Product Change Notification

Product Change Notification: PCN-22-125558

PE & RE/L relay series - Change for relay sealing:

The color of the adhesive before the change (orange)

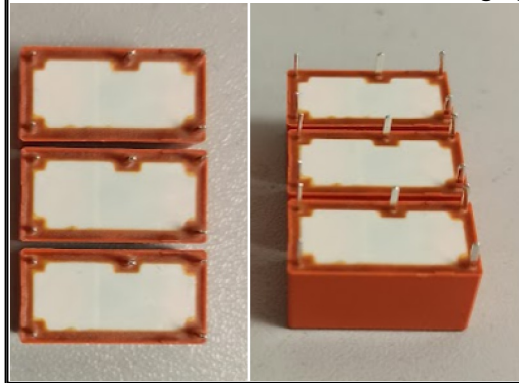
PE & RE/L relay series - Change for relay sealing: Dear customer, to keep aligned with the regulations of RoHS not just for the finished relay but also throughout the complete process of production we change the sealing adhesive. The improved adhesive appears white at the bottom of the relay. The qualification tests did not show any difference to the current adhesive (orange color).
